## Obsolescence of Series SPD125 / Last Time Buy Notification

**Description of Change:** API Delevan announces the end of life for Product Series SPD125.

**Series/Families Affected:** SPD125

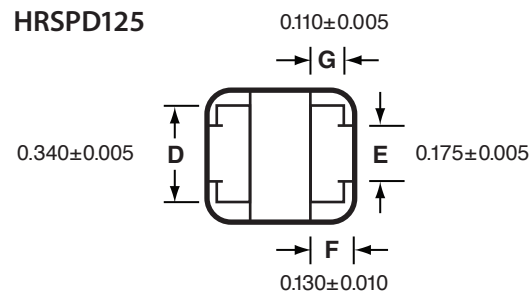
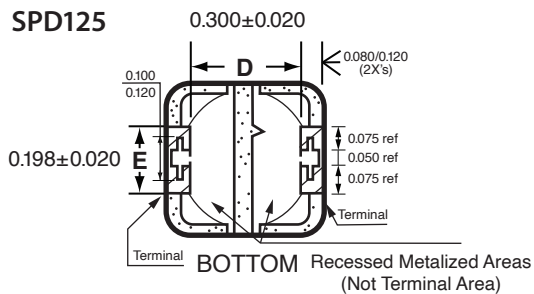
### Expected Impact on Form / Fit / Function:

**SPD125 Height Dimension 'C'**  
0.236 Inches Max (6.0 mm Max)  
**SPD125 Terminal Dimensions**  
0.198 ± 0.020 0.340 ± 0.005 Total Length (in)

**HRSPD125 Height Dimension 'C'**  
0.283 Inches Max (7.20 mm Max)  
**HRSPD125 Terminal Dimensions**  
0.100 ± 0.020 0.130 ± 0.010 Total Width (in)

**Replacement Series:** [HRSPD125](#)
